Item ID: D407-667-205

Item Name: Crosstube Aft

D407-667-245	Rev F/DEO
--------------	-----------

DRAWING NO. D407-667-245	TITLE CROSSTUBE ASSY (407 HIGH AFT)	REV. F	DART AEROSPACE LTD ENGINEERING ORDER		D.E.O. NO. D407-667-245-F-1	SHEET NO. SHEET 1 OF 2	SCALE NTS
DRAWN [Signature]	CHECKED [Signature]	MFG. APPR. [Signature]	APPROVED [Signature]	DE APPR. [Signature]			
DATE 11.04.08	DATE 11.04.12	DATE 11.04.12	DATE 11.04.12	DATE 11.04.12

DRAWING NO. D407-667-245	TITLE CROSSTUBE ASSY (407 HIGH AFT)	REV. F	DART AEROSPACE LTD ENGINEERING ORDER	D.E.O. NO. D407-667-245-F-1	SHEET NO. SHEET 2 OF 2	SCALE NTS
DRAWN	CHECKED	MFG. APPR.	APPROVED	DE APPR.		
DATE 11.04.08	DATE 11.04.11	DATE 11.04.12	DATE 11/04/12	DATE 11.04.12

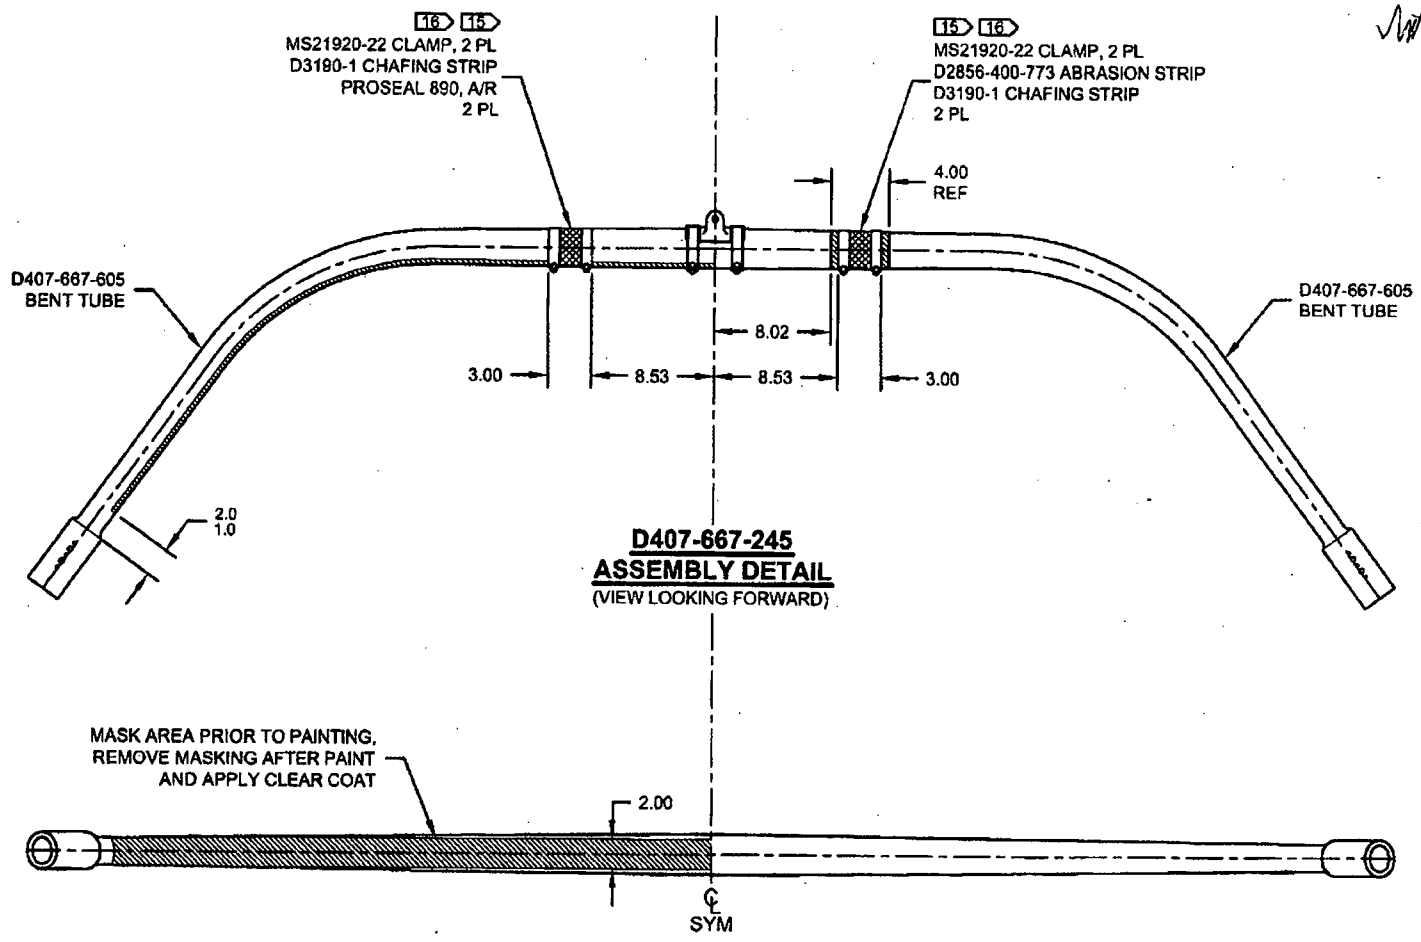
CHANGE:

NOTES 2 AND 15, SHEET 1 ARE AMENDED AS FOLLOWS:

- 2) FINISH: CHEMICAL CONVERSION COAT PER DART QSI 005 4.1
PRIME INSIDE AND OUTSIDE PER DART QSI 005 4.2
MASK UNDERSIDE OF CROSSTUBE AS SHOWN (HATCHED AREA) AND
PAINT OUTSIDE PER DART QSI 005 4.2
REMOVE MASKING AND APPLY CLEAR COAT
- 15) APPLY A THIN COAT OF PROSEAL 890 ON INSIDE CONCAVE SURFACE OF D3190-1
CHAFING SHIELDS AND LET CURE PER MANUFACTURER'S INSTRUCTIONS. INSTALL
PROSEALED D3190-1 CHAFING SHIELDS ONTO CROSSTUBE BY APPLYING A THIN COAT
OF PROSEAL 890 ONTO CROSSTUBE. BE SURE TO ELIMINATE ANY AIR GAPS.

IS:

WAS:
